ADDENDUM NO. 1

Job No. F70C616E
SAND ISLAND STATE RECREATION AREA
SEWER SYSTEM IMPROVEMENTS
PHASE 2: PUMP STATION 3 RELOCATION & FM 3 REPLACEMENT
Honolulu, Oahu, Hawaii

02/22/21

PHASE 3 – DEMO SFM AND EX PS 3
SCALE: 1" = 100'

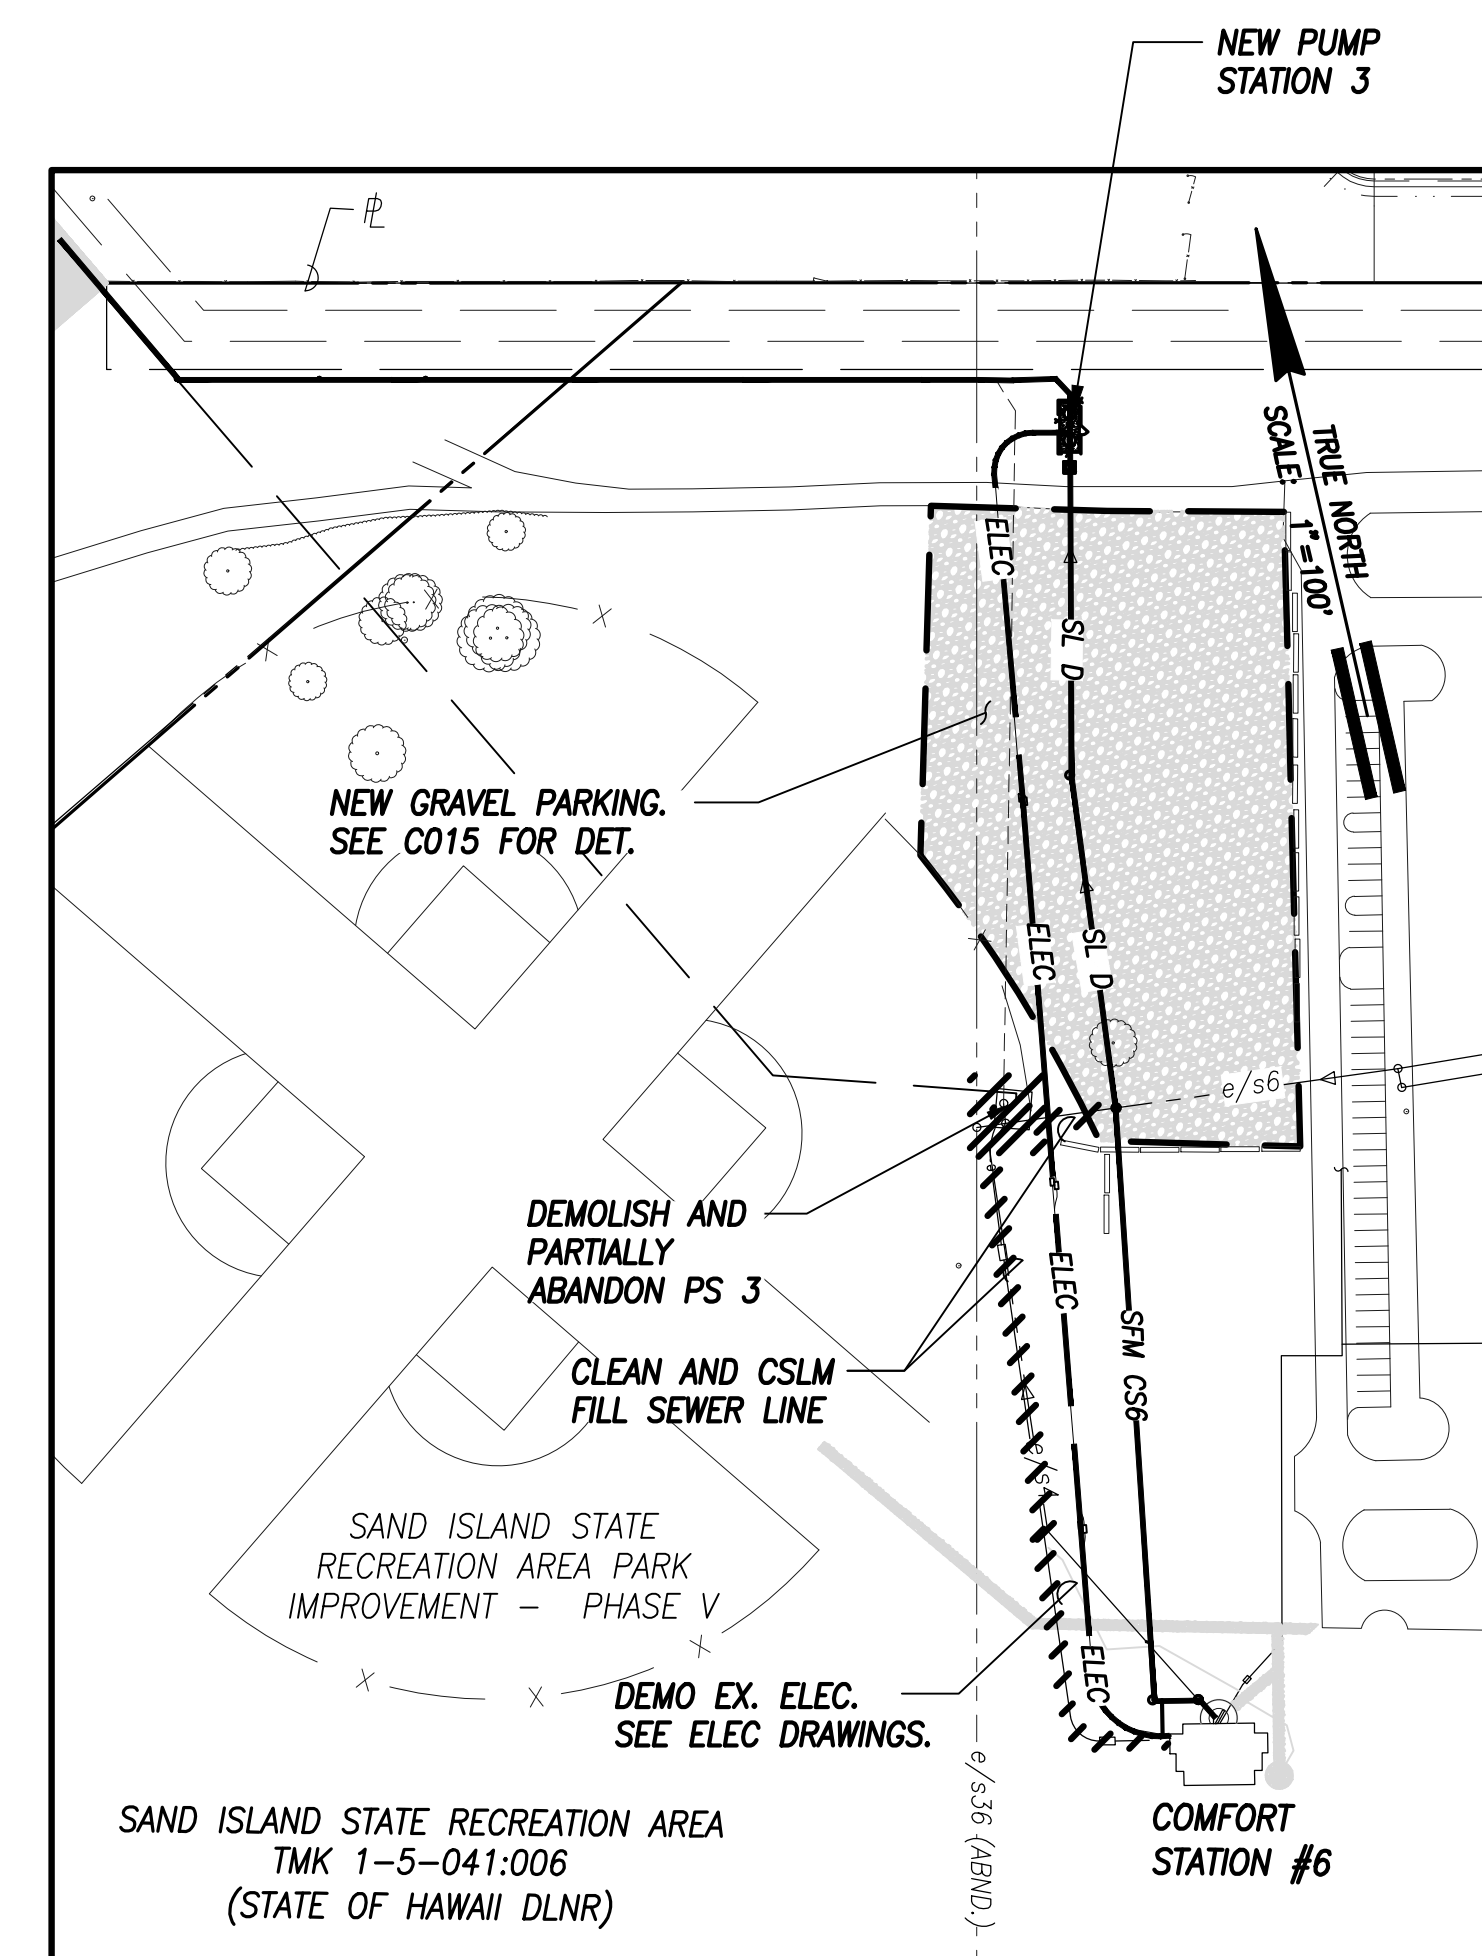
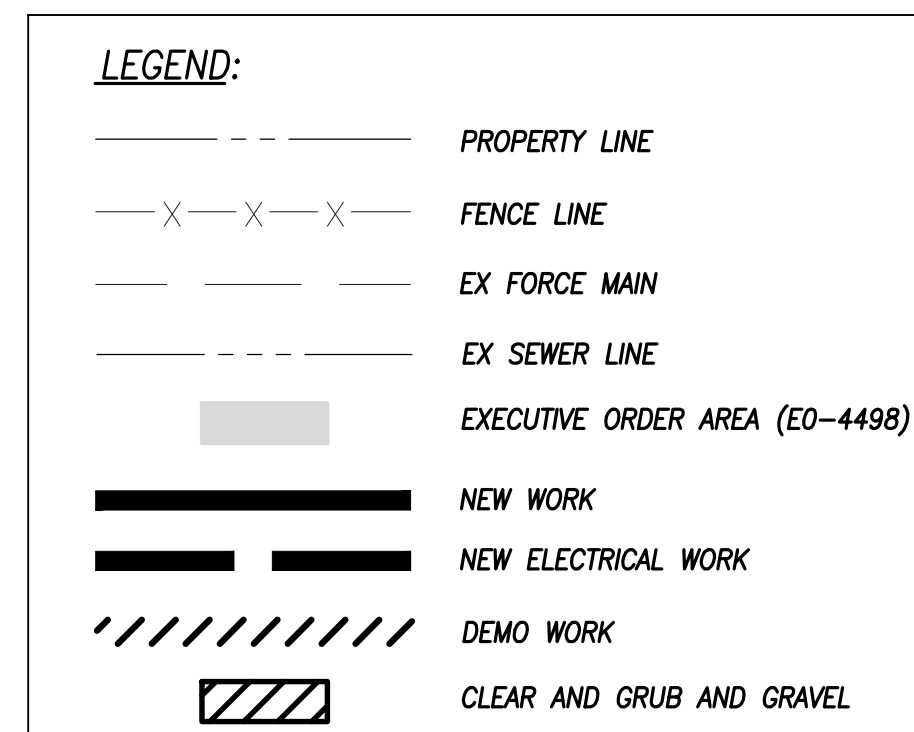
- 1. Sheet C005A, “Phasing Plan.”
- 2. Sheet C006A, “Demolition Plans – 1”
- 3. Sheet C006B, “Demolition Plans – 2”
- 4. Sheet C020A, “Chain Link Fence Details”

46. Sheet C005, note 1 state “Contractor must complete installation and testing of Phase 1 work and be cleared out of the EO-4498 area by June 7th, 2021. No Exceptions.” However, page P-11 of the proposal states that completion of Phase 1 of the contract shall be by June 25, 2021. Please clarify when phase 1 is to be complete.

Answer: See revised proposal in this addendum. Phase 1 to be completed by June 7, 2021. Also, the completion date for Phase 1 in the last paragraph of Section Q in the Information to Bidders Section of the Specifications shall be changed to June 7, 2021.

| 1 | ADDENDUM NO. 1: REPLACE C006 | 6 of 25 | 2/19/2021 | | |
|---|------------------------------|-------------|-----------|------|----------|
| APPROVED: | | DRAWING NO. | C006A | | |

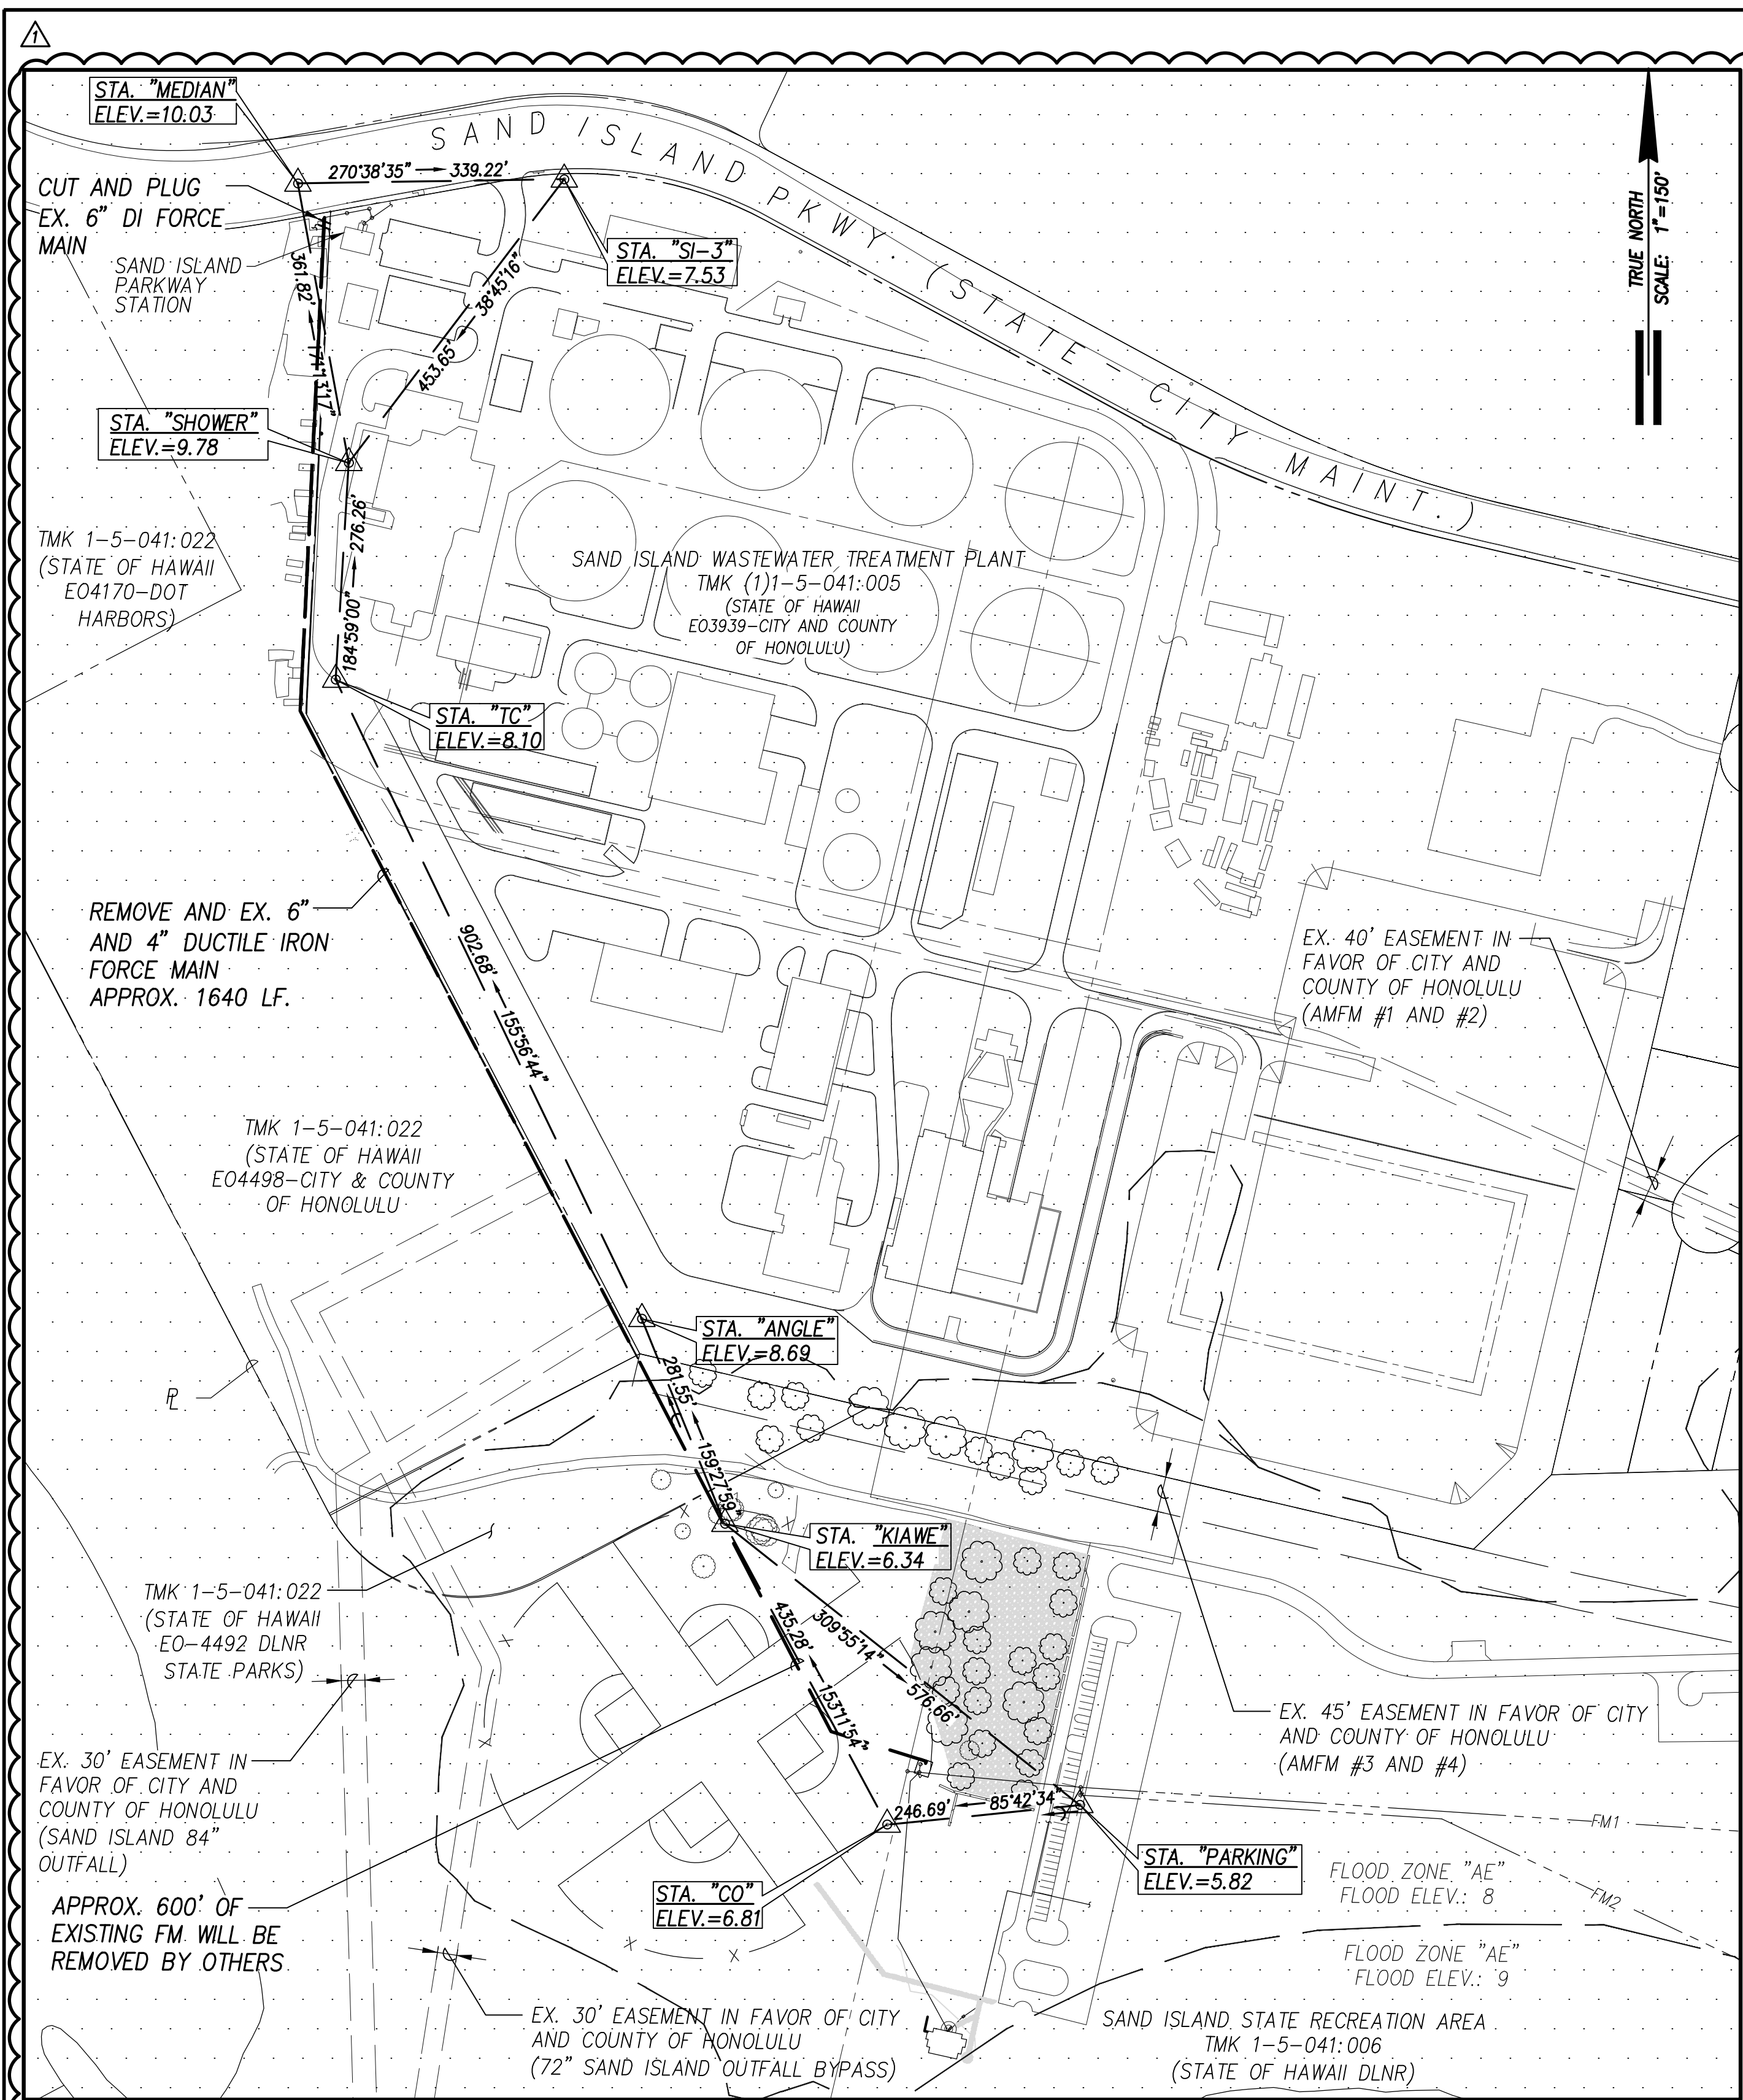
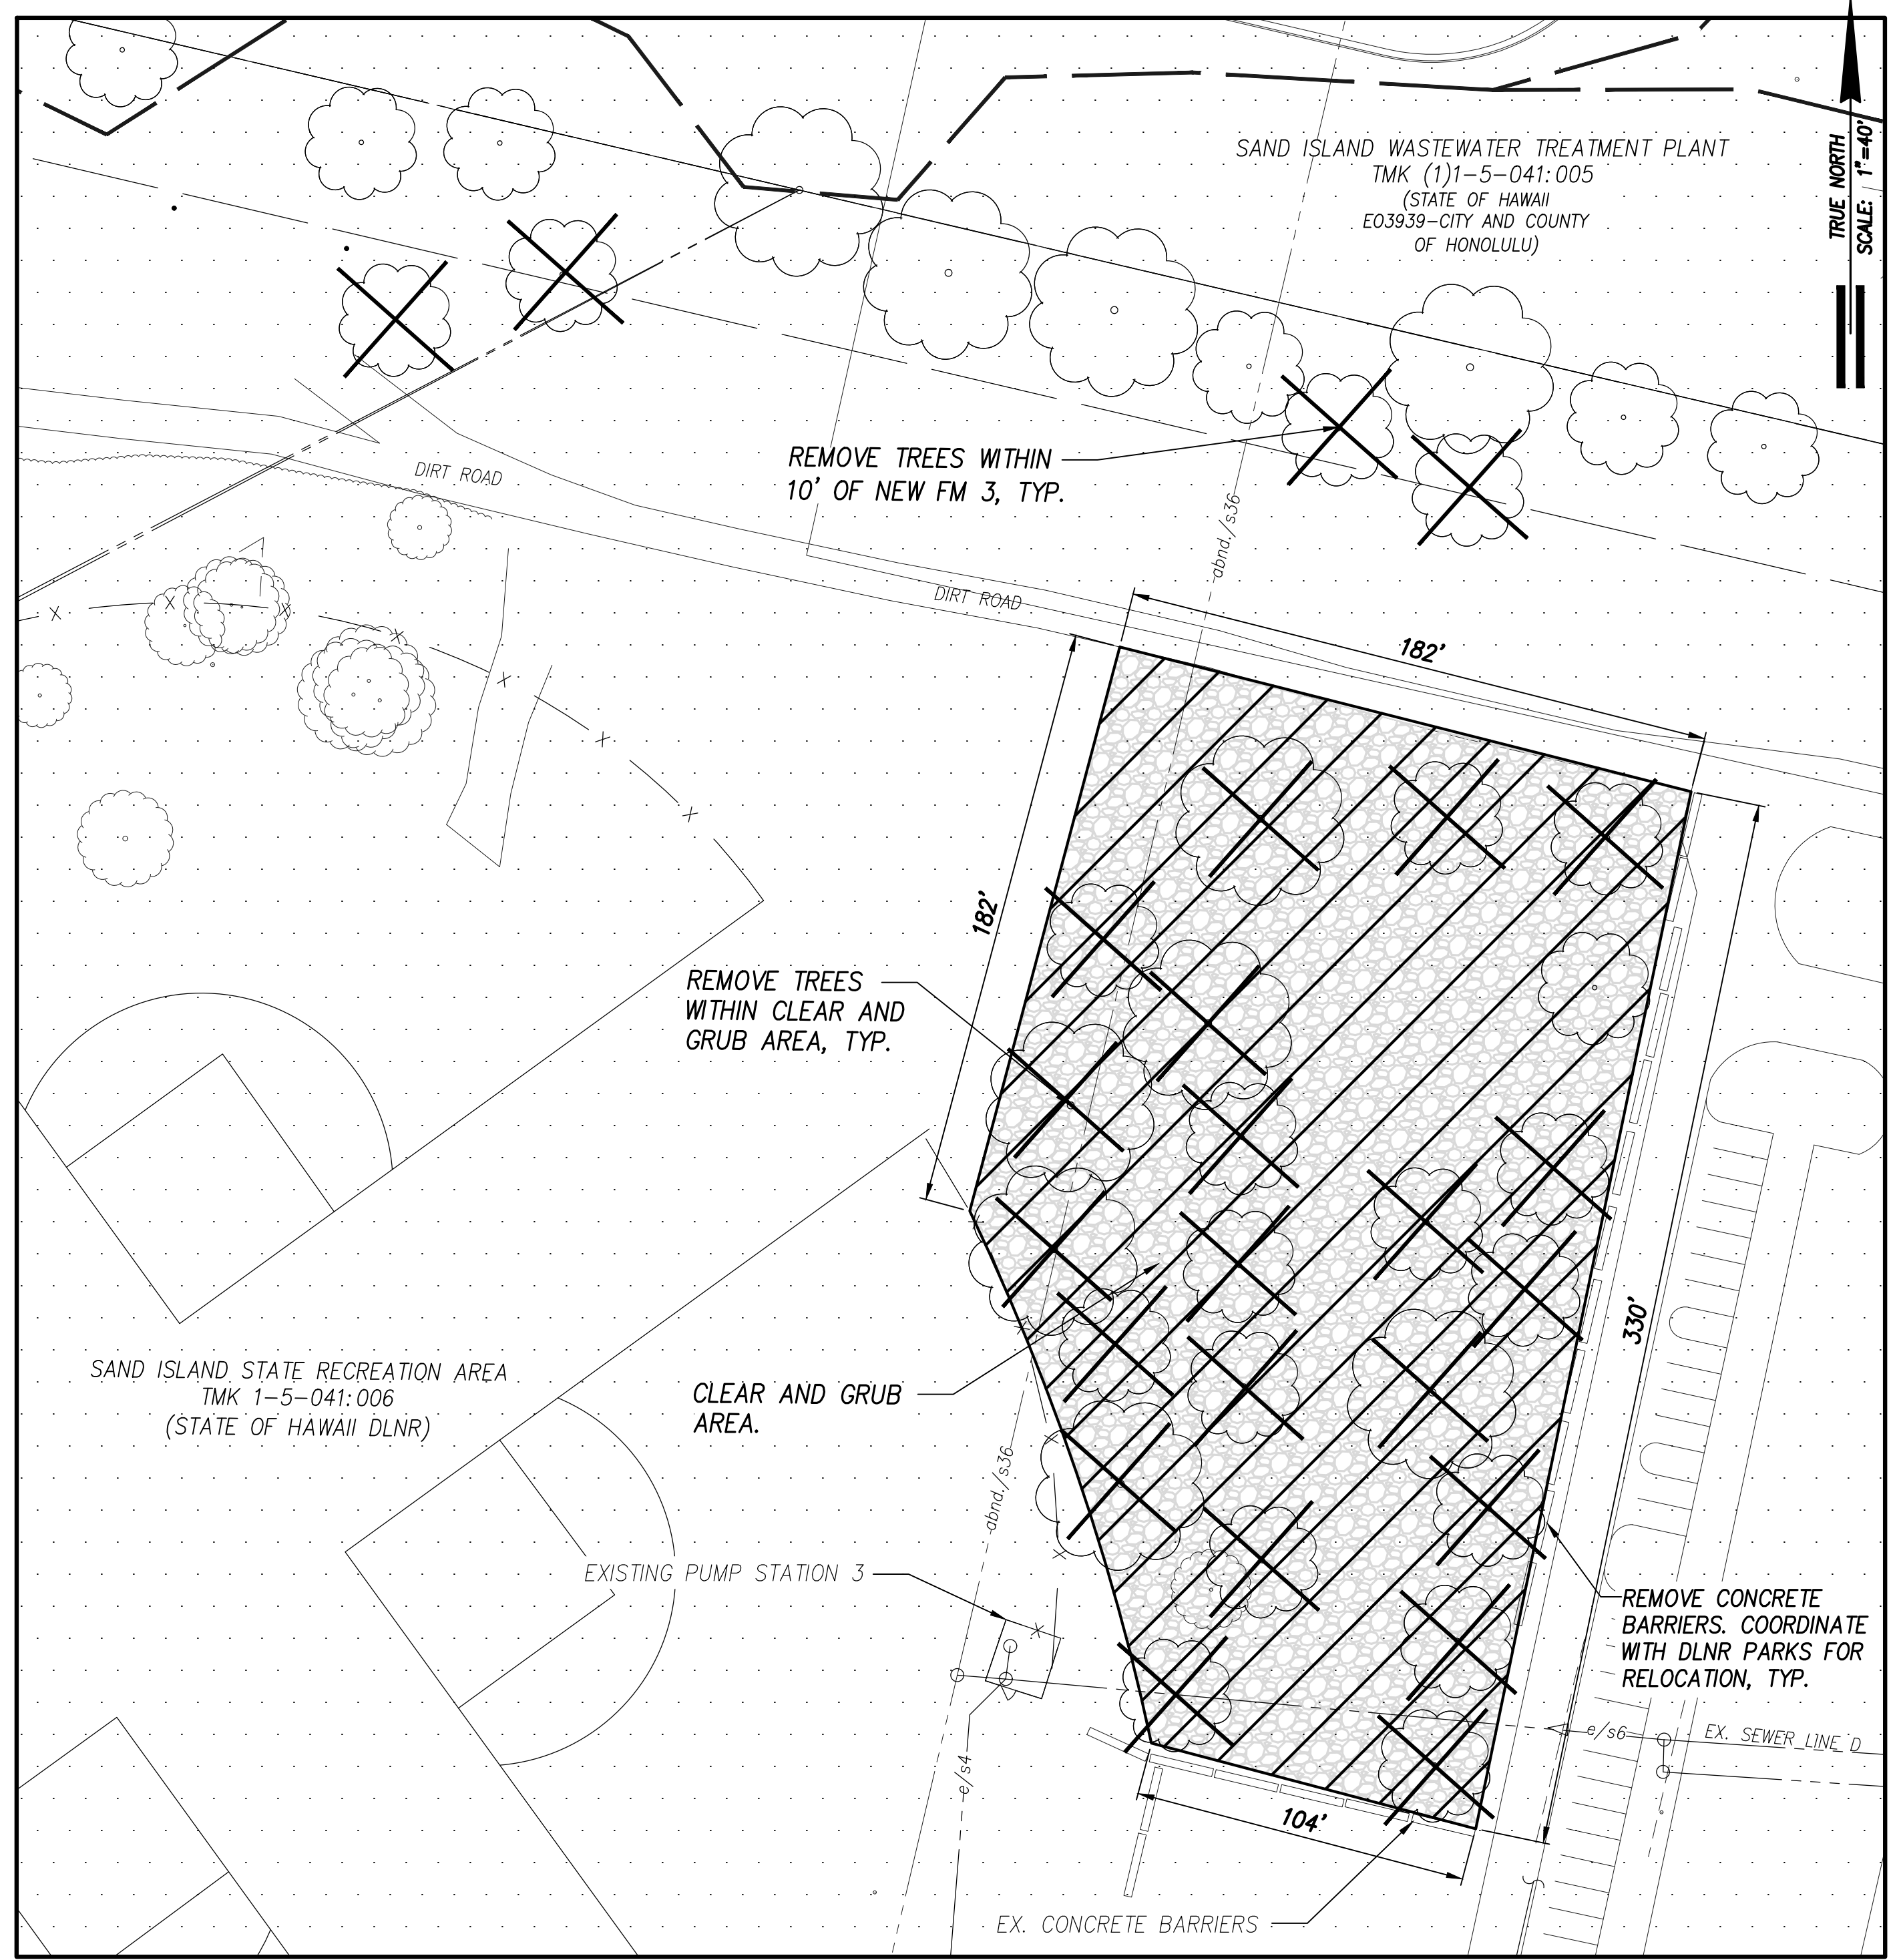
11. Drawing C006 shows "remove and replace ex. 6" and 4" ductile iron force main approx. 2200 LF.". Please advise where we need to put the cost on proposal schedule. Proposal schedule only shows 600 LF of demolition 4" force main.

Answer: See revised Proposal Schedule and new Demolition Plans -1, drawing C006A in this addendum
